**Re: GE-Pittsfield/Housatonic River Site  
Building 71 and Hill 78 On-Plant Consolidation Areas (GECD200)  
2006 Addendum to OPCA Work Plan**

# **OPCA Operations Enhancements/ Additional Requirements**

GENERAL ELECTRIC COMPANY  
 PITTSFIELD, MASSACHUSETTS  
**ON-PLANT CONSOLIDATION AREAS**  
**TRAVEL ROUTES TO AND FROM OPCAs,**  
**BUILDING 78 RCRA PART B STORAGE**  
**FACILITY, & 64-G TREATMENT FACILITY**

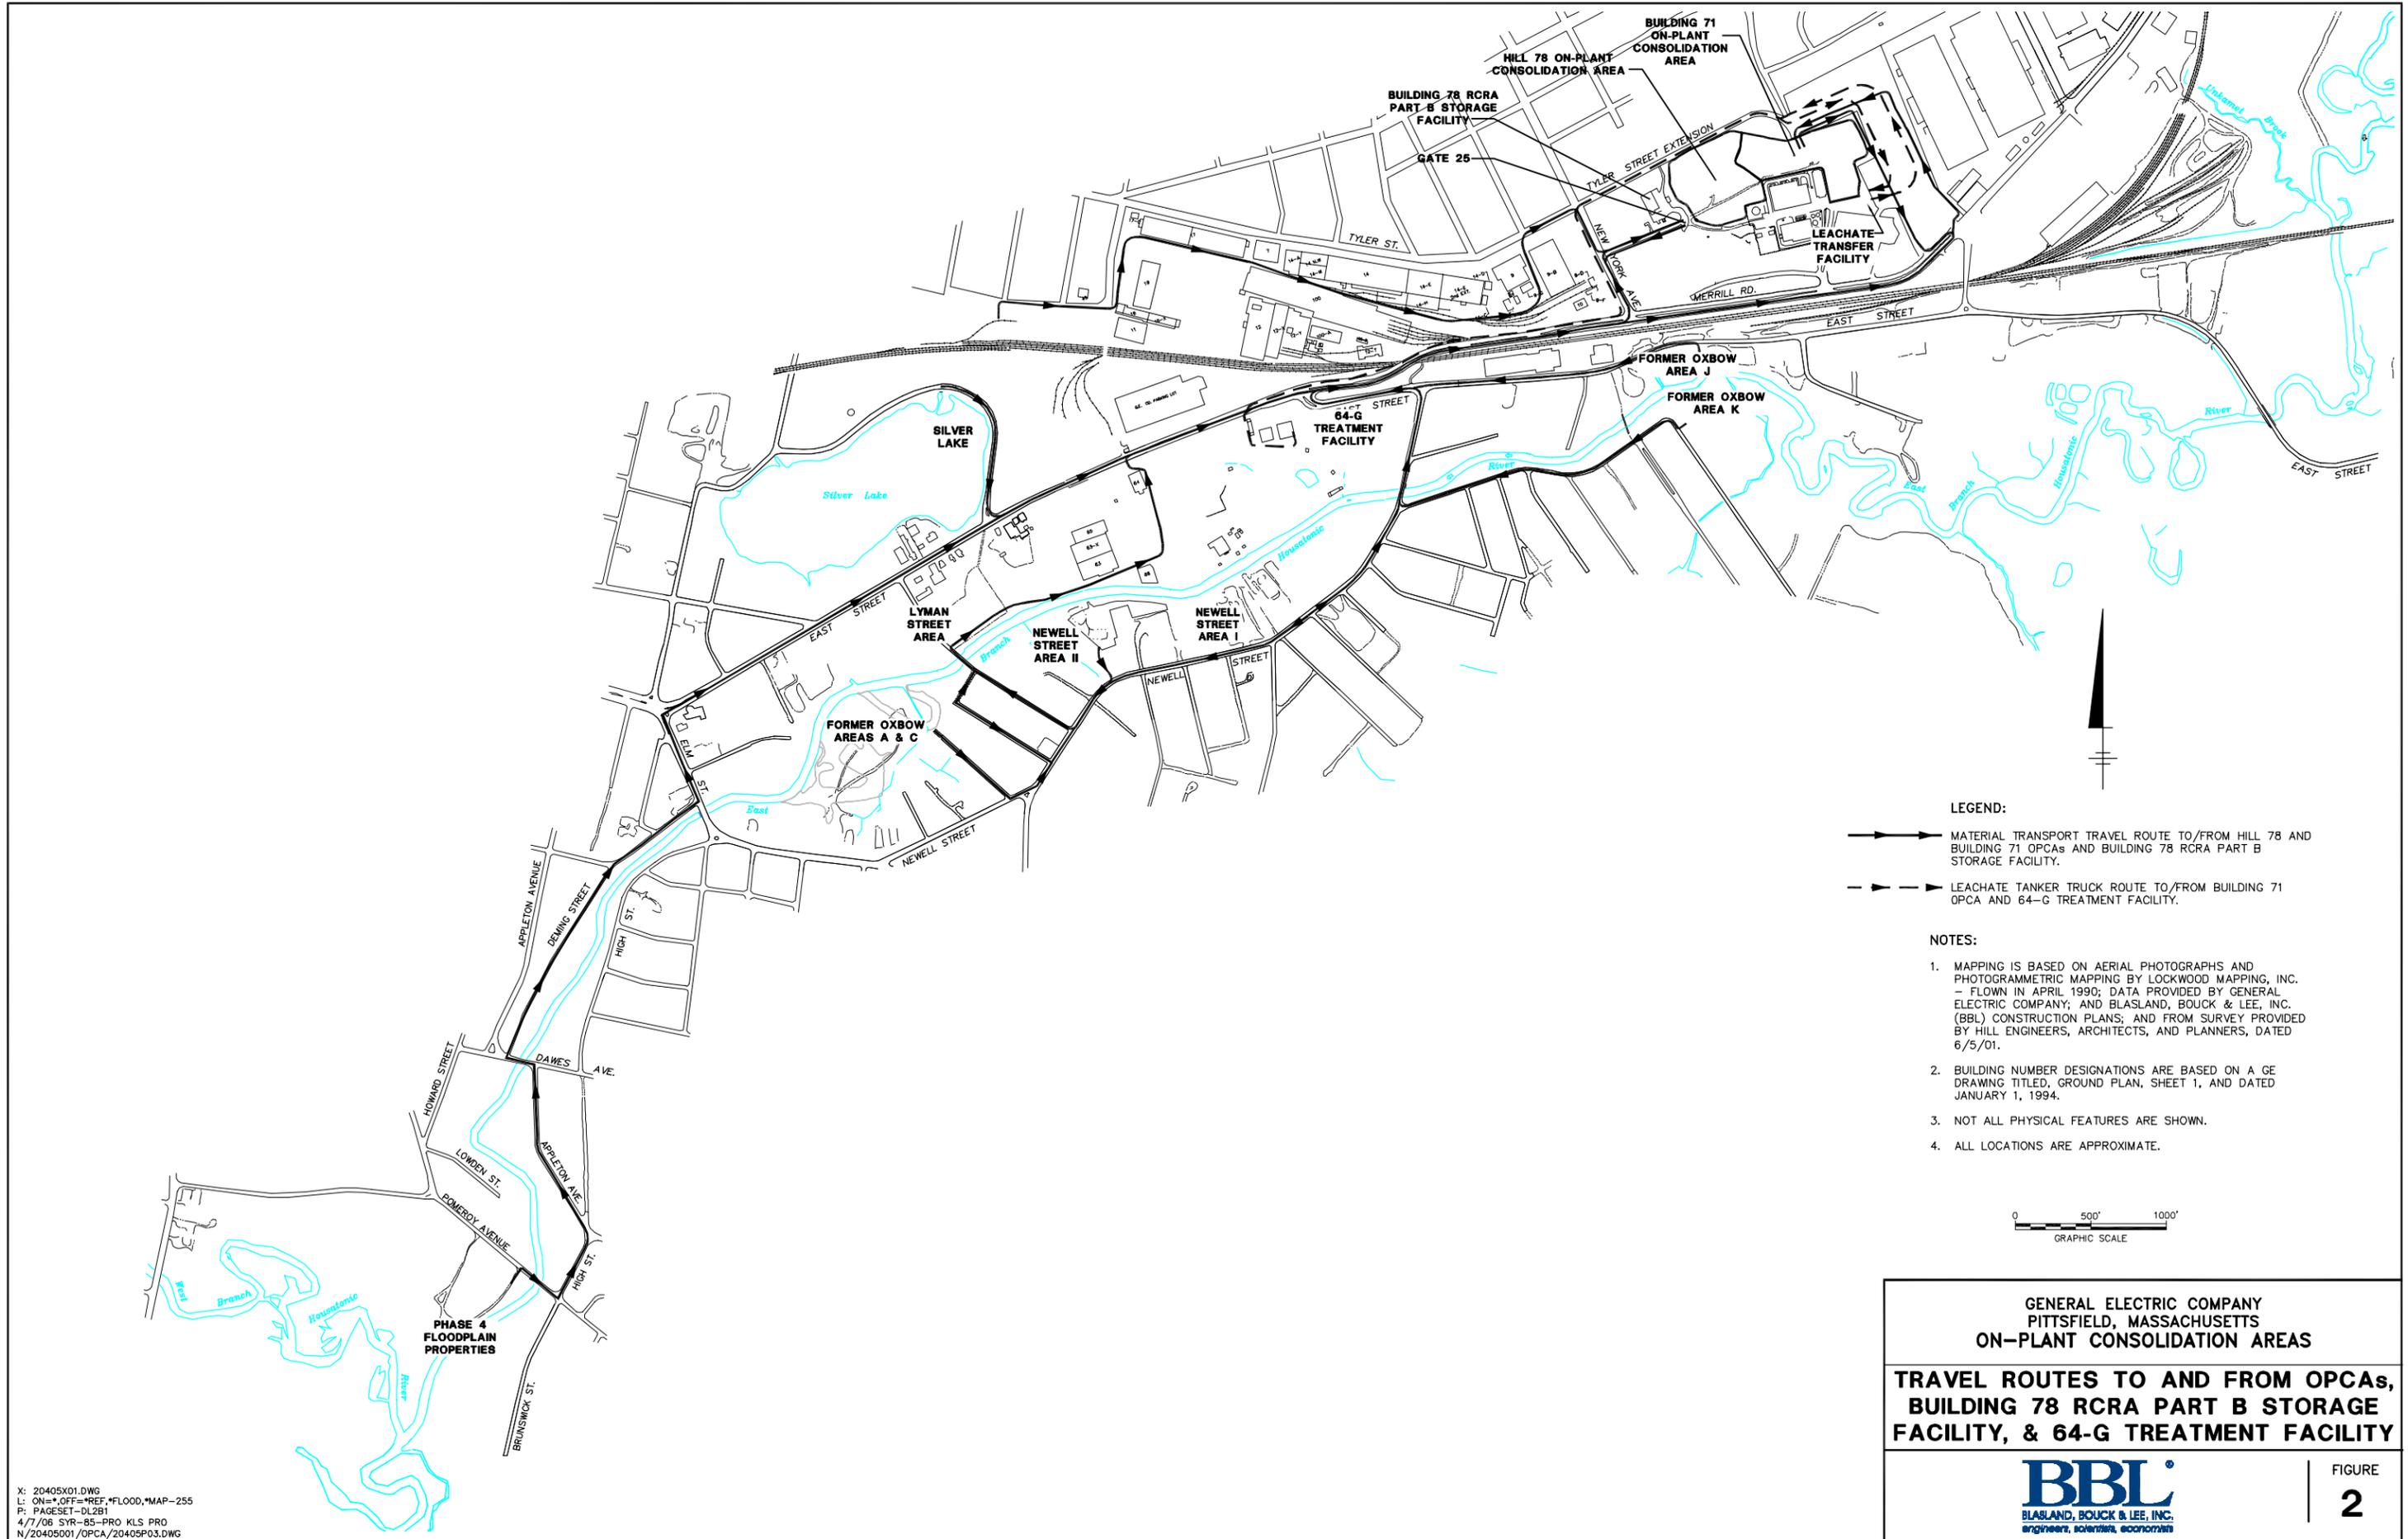
The typical transportation route for hauling materials to the OPCAs previously accessed the consolidation areas using Tyler Street Extension, which is located between the OPCAs and the Allendale School property. The OPCA trucking route has been modified so that, beginning in 2006, transport vehicles will access the Hill 78 OPCA using Tyler Street or Merrill Road, New York Avenue, and Gate 25 located southwest of the Hill 78 OPCA. When accessing the Building 71 OPCA, access will be via Merrill Road, the General Dynamics parking lot, and the gate located on the north side of the Building 71 OPCA. This modified trucking route will result in only leachate tanker trucks traveling to or from the OPCAs along Tyler Street Extension between the OPCAs and Allendale School. The new transportation routes to and from both OPCAs are shown on Figure 2.

In addition, the modified route shown for transport to and from the Hill 78 OPCA will also be used for the transport of remediation-related waste materials from the GE-Pittsfield/Housatonic River Site (as defined in the CD) to GE's RCRA Part B-permitted hazardous waste storage facility at Building 78. These include, for example, such materials as non-aqueous-phase liquid (NAPL) (including both light and dense NAPL), filter cake from the Building 64G water treatment facility, solid materials from Removal Actions that constitute hazardous waste, oil from the oil recovery systems, and water recovered from the ground in connection with the groundwater monitoring programs and destined for off-site disposal. Similarly, the modified route shown for transport to and from the Building 71 OPCA leachate transfer facility will be used for the transport of leachate from that OPCA to the Building 64G treatment facility.
